8/9.9 2005 Model Year FourStroke Reverse Hook Replacement

Models Covered	Serial Number Or Year
Mercury/Mariner 8/9.9 Hp FourStroke	Serial numbers 0R042475 through 0R053618

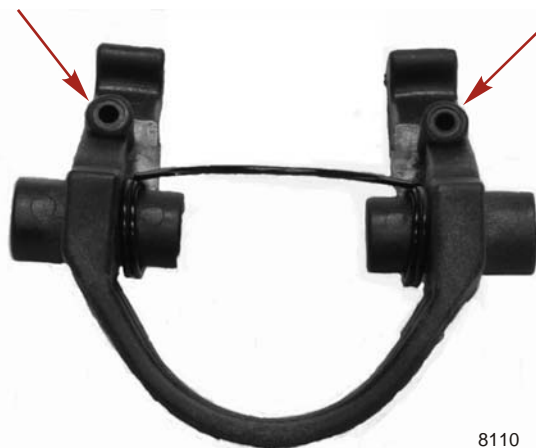
- Engines reworked at the factory will have an orange dot designation on the outside of the box.
- New reverse hook 42141 1 will be identified by the two molded marks illustrated in the following picture.

Mercury Marine will supersede the current reverse hook part number to 42141 1.
